City of Phoenix Office of the City Engineer Design and Construction Procurement

HAPPY VALLEY ROAD: 67TH AVENUE TO 35TH AVENUE ROADWAY IMPROVEMENTS DESIGN-BID-BUILD

> PROJECT NO. ST85100437 FEDERAL AID NO. PHX-0(363)D ADOT TRACS NO. T0239 01C

ADDENDUM NO. 2

REVISION BY CITY OF PHOENIX REV BY CKD BY DATE DESCRIPTION NOTES UPDATE CMW TWT

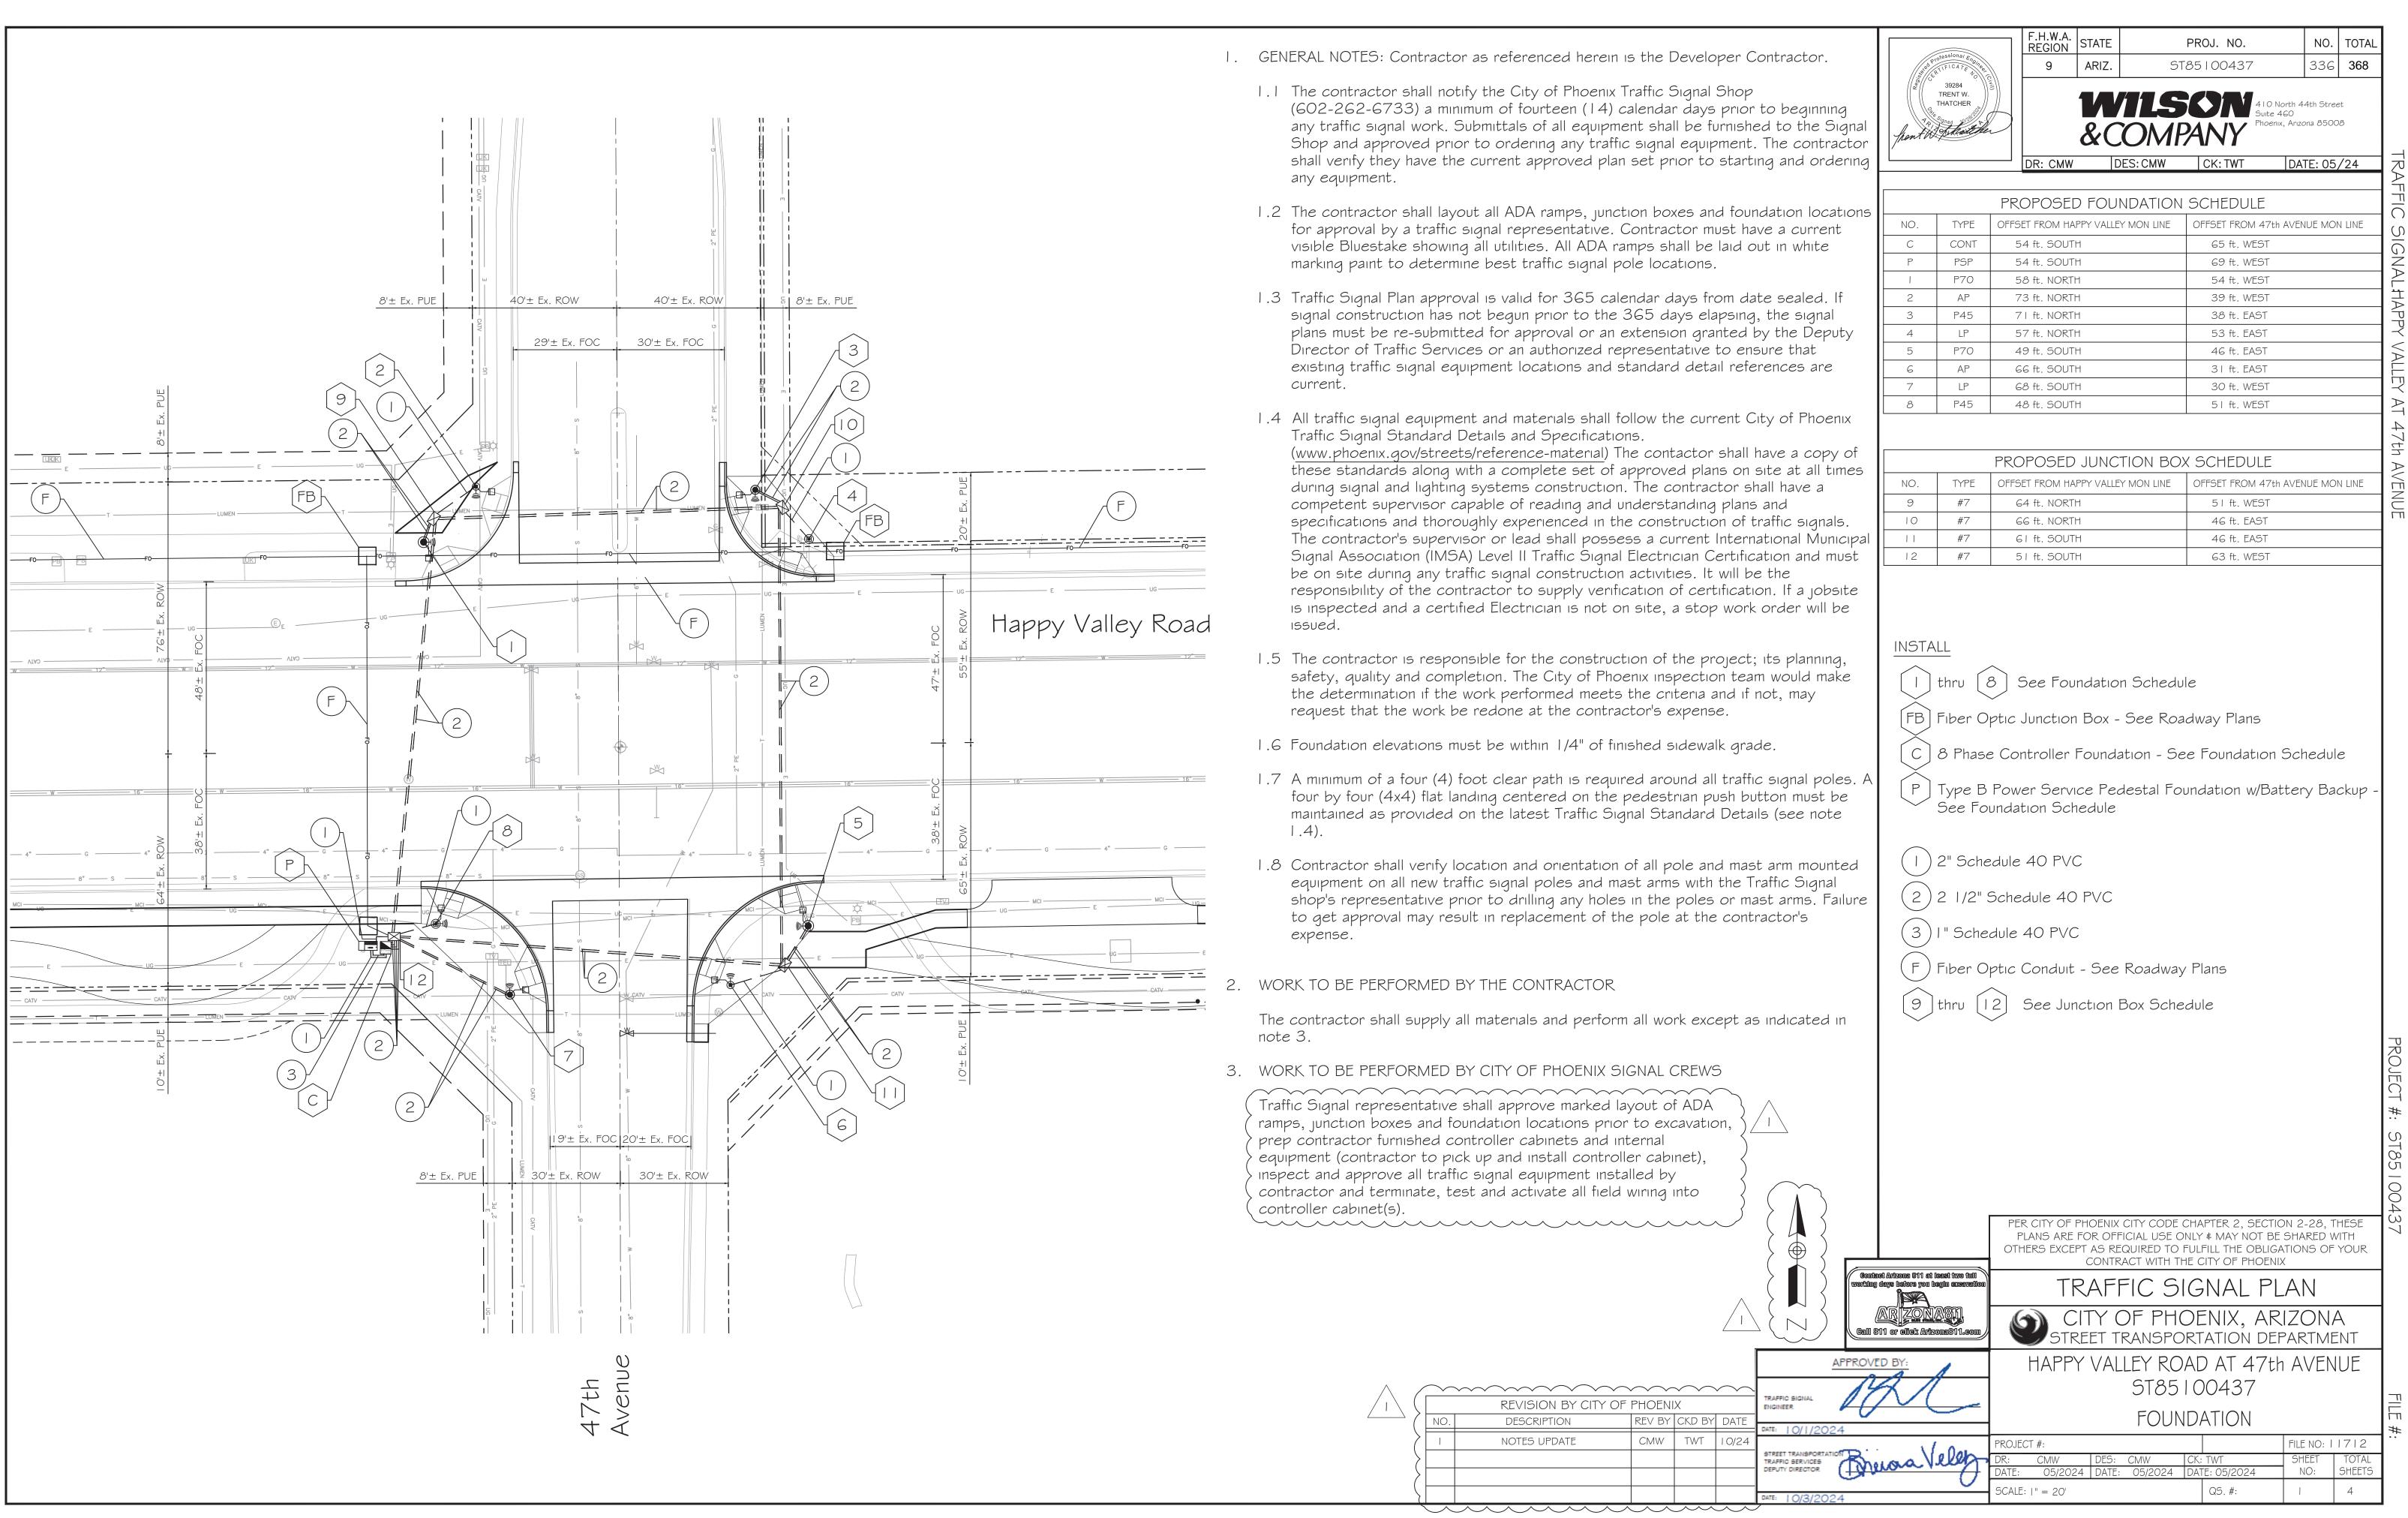
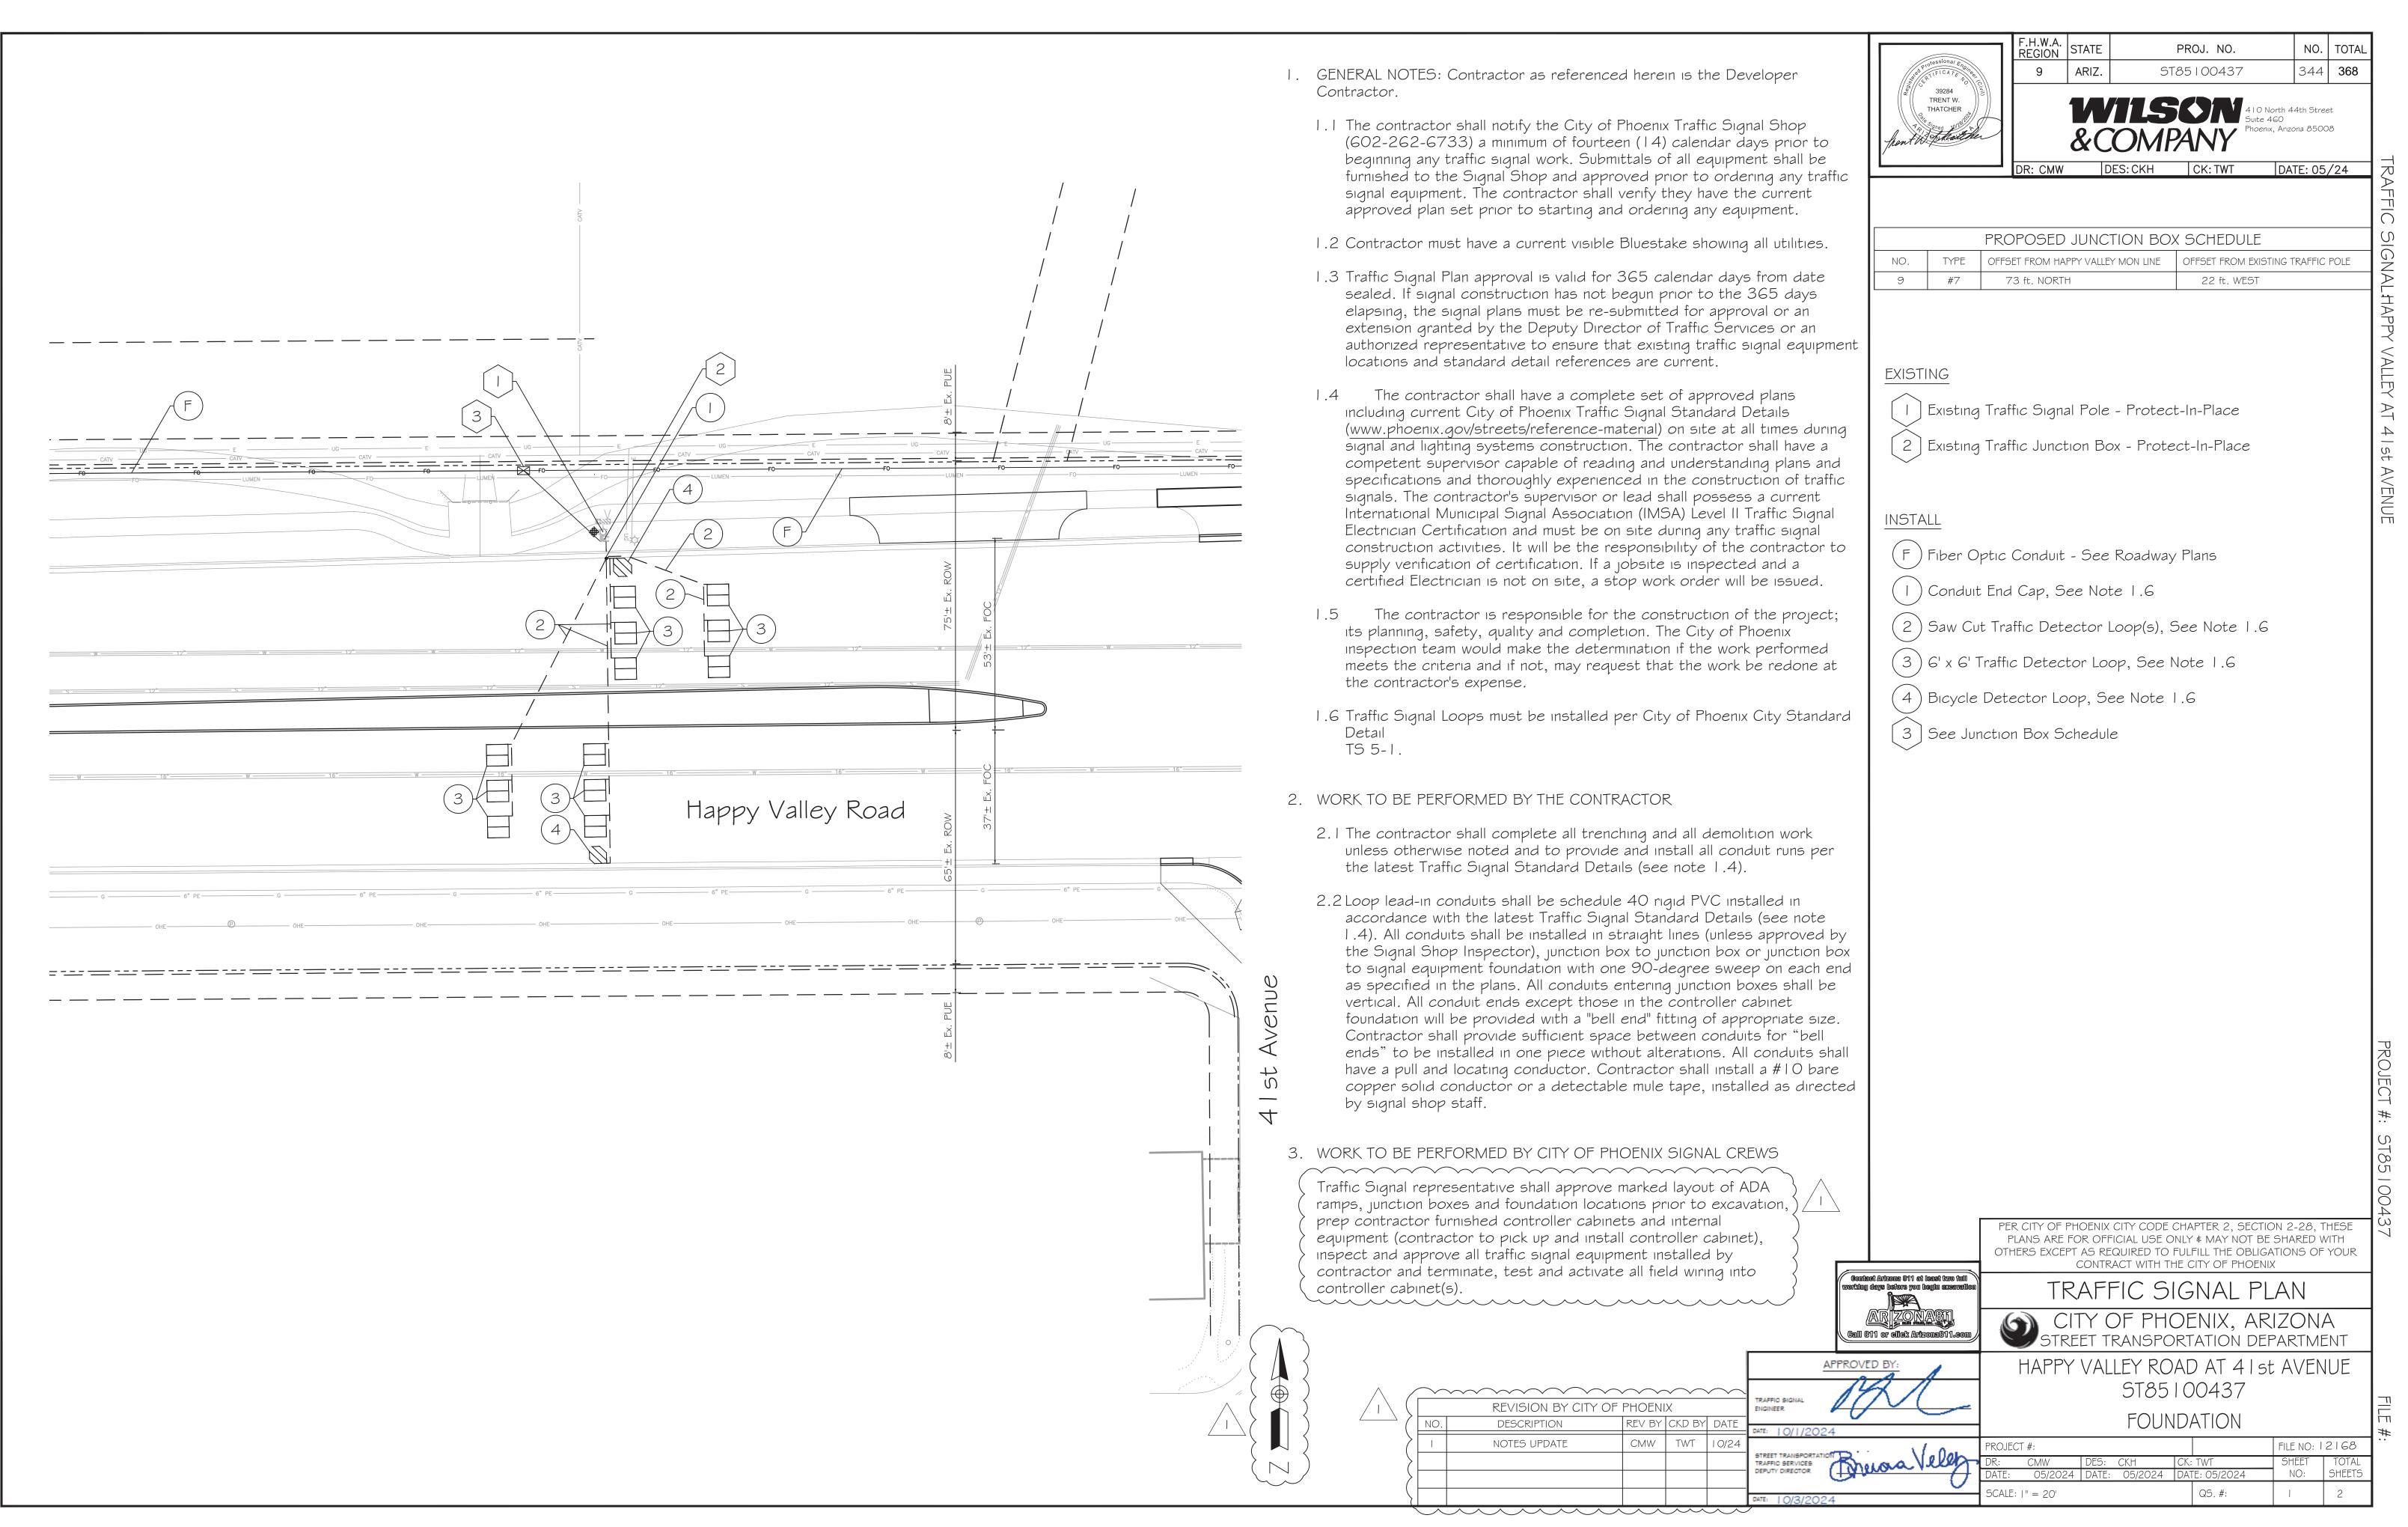
- Q21. Clarify what electrical materials are being provided and installed by the City. The special provisions, pay items and the traffic signal plans and details (specifically note 3) contradict each other.
- A21. Plans: Note 3 on Wilson & Company's traffic signal sheets reflects a non-federal aid note to contractors. See attached revised plans. Replace Note 3 on sheets 320, 328, 336, 344, and 346 with the following:
 - 3. WORK TO BE PERFORMED BY CITY OF PHOENIX SIGNAL CREWS
 Traffic Signal representative shall approve marked layout of ADA ramps, junction boxes
 and foundation locations prior to excavation, prep contractor furnished controller
 cabinets and internal equipment (contractor to pick up and install controller cabinet),
 inspect and approve all traffic signal equipment installed by contractor and terminate,
 test, and activate all field wiring into controller cabinet(s).
